Section 5 Application

5 – 6 Henry St Limerick

Conversion of a ground floor retail space to a studio apartment and
addition of roof light to existing flat roof with a rear aspect only.

Report on application under Section 5 of the Planning and Development Act 2000 (as amended)

5 - 6 HENRY STREET
GROUND FLOOR PLAN
SECTION 5 APPLICATION OUTLINED IN RED

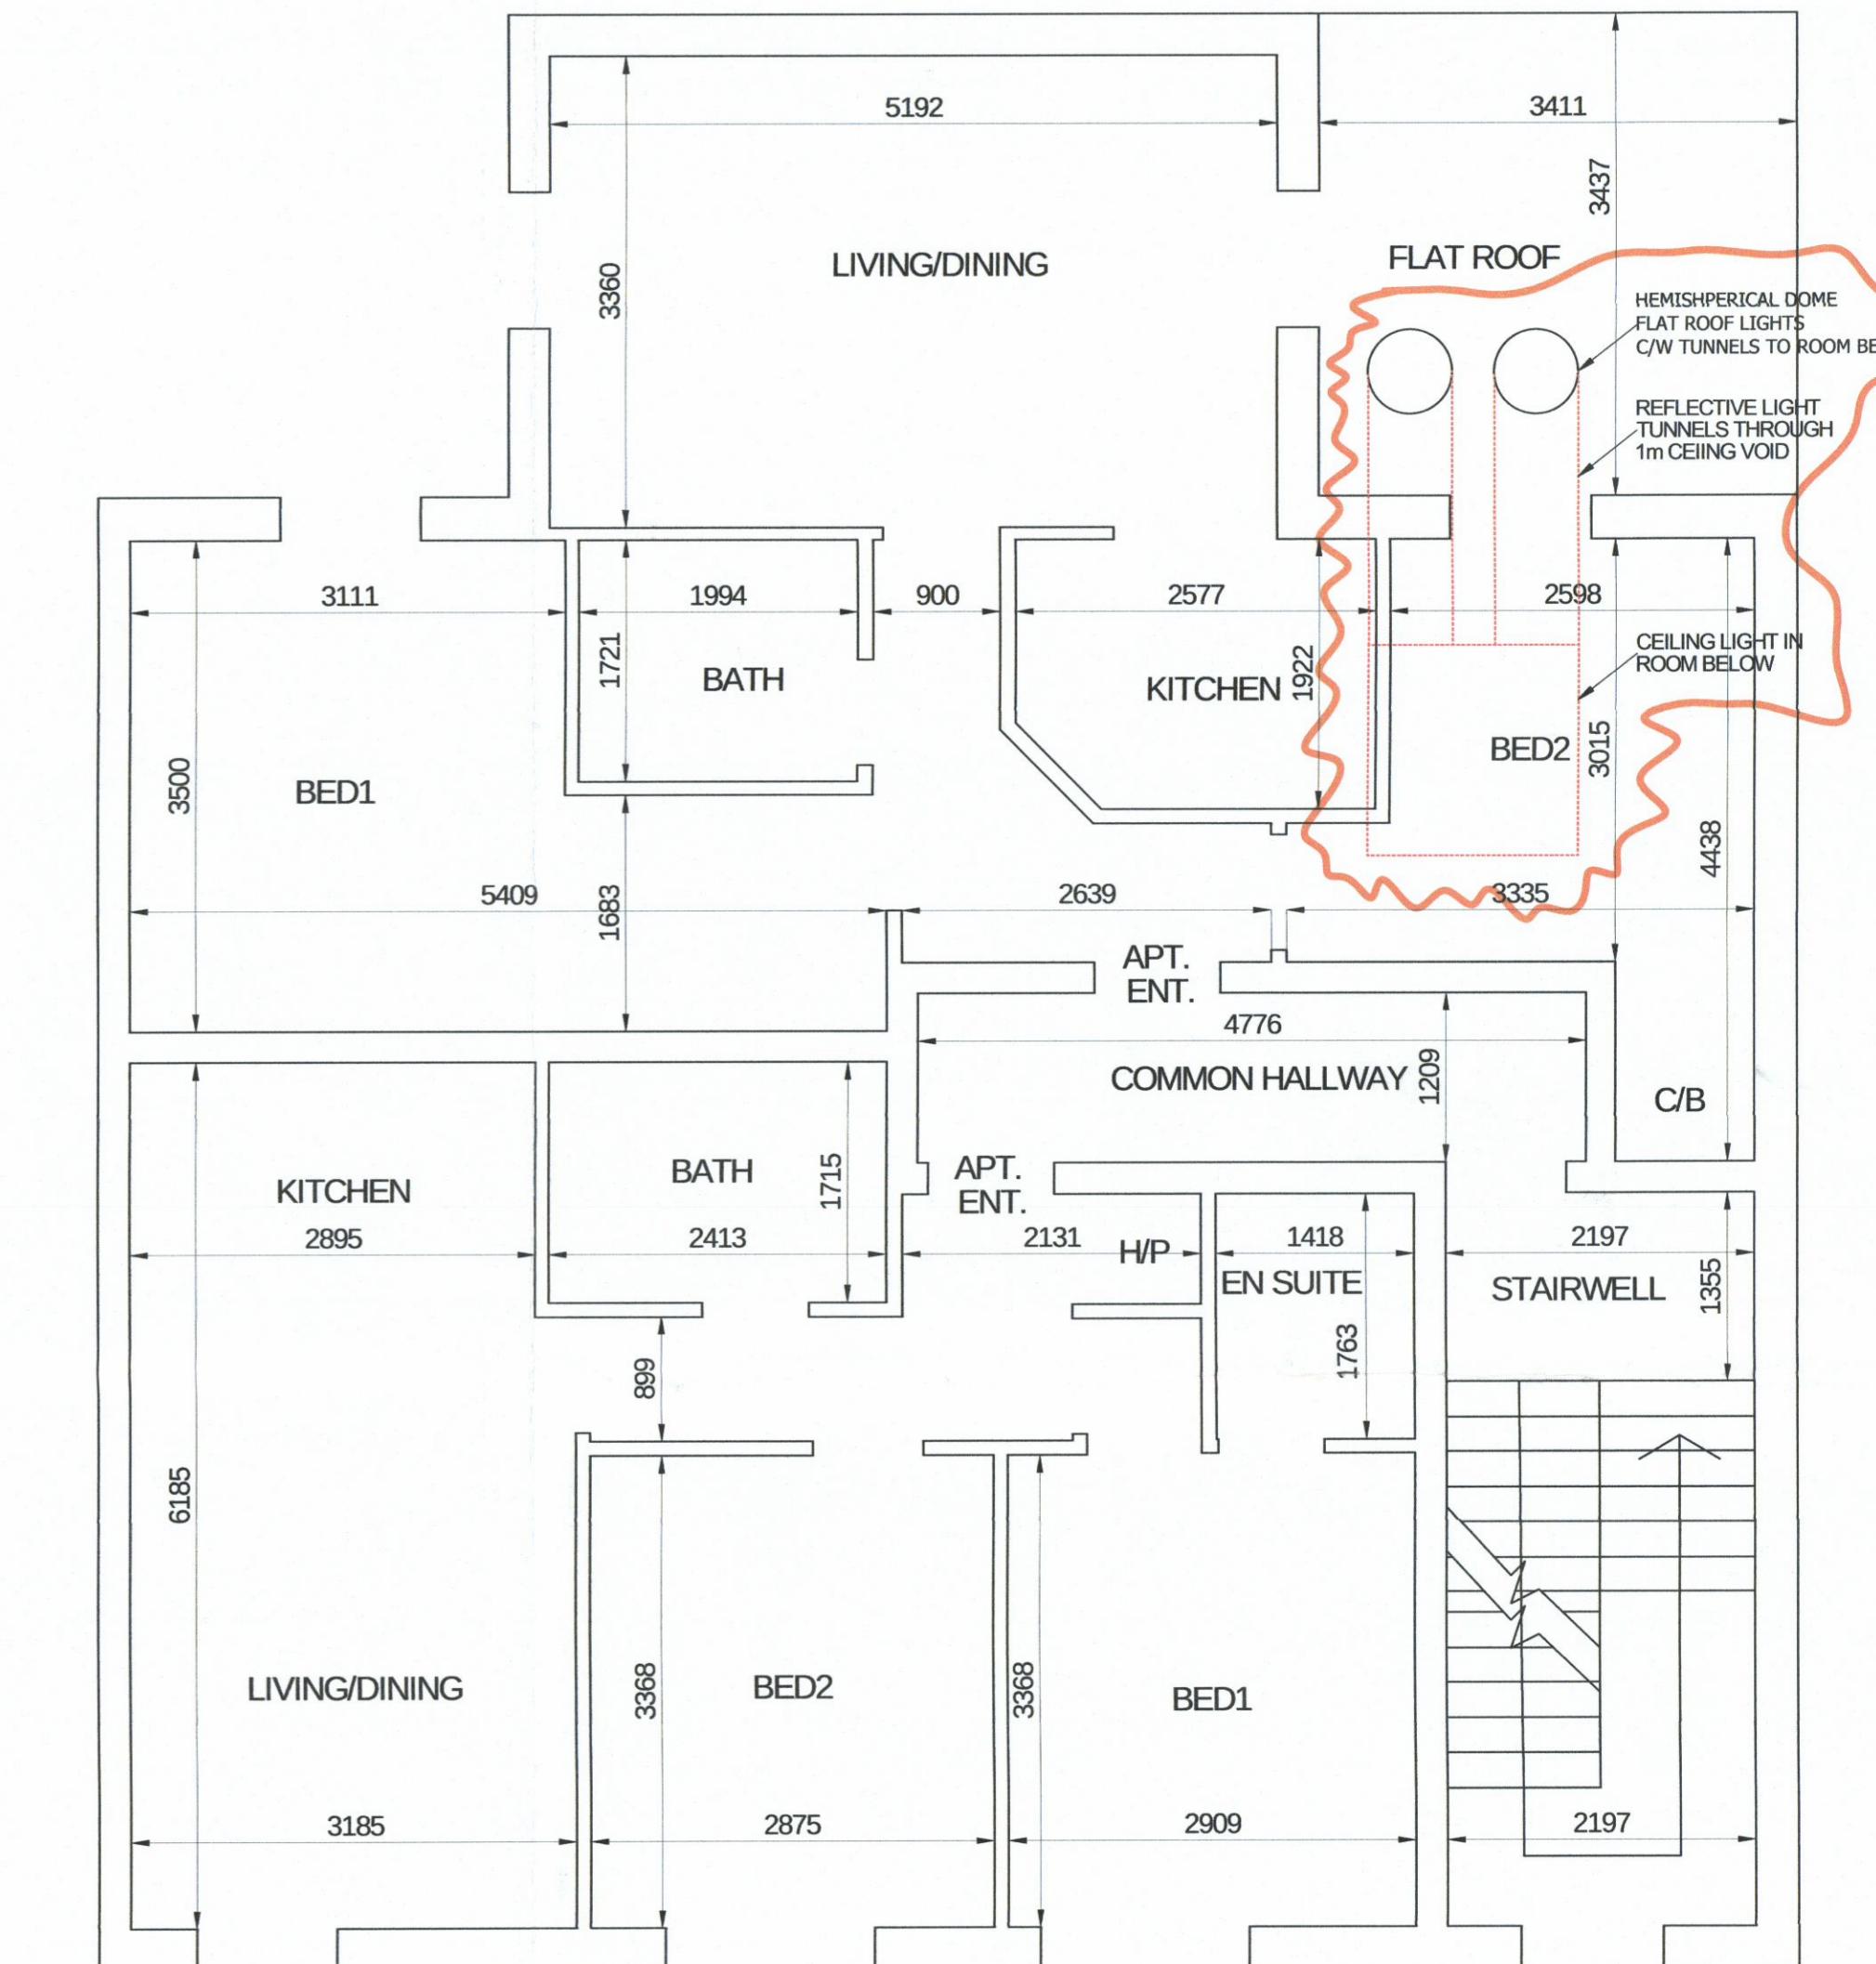
Drawings submitted indicate that the apartment will receive natural light from the front window/door. A new skylight is being proposed above the bedroom which is to be located within the void of ground and first floor. Hemispherical dome flat roof lights are proposed above the bathroom and storage area to the rear and reflective light tunnels through the ceiling void to provide light through the proposed roof light in the void. The applicant has submitted a daylight calculation report carried out by Gabor Molnar Engineering to include the effect of the flat roof light and concludes that the bedroom and living would be sufficiently lit. It notes that the kitchen area to the rear will require supplementary lighting all year round to achieve 200 Lux light levels. However, this part of the unit would not be considered habitable.
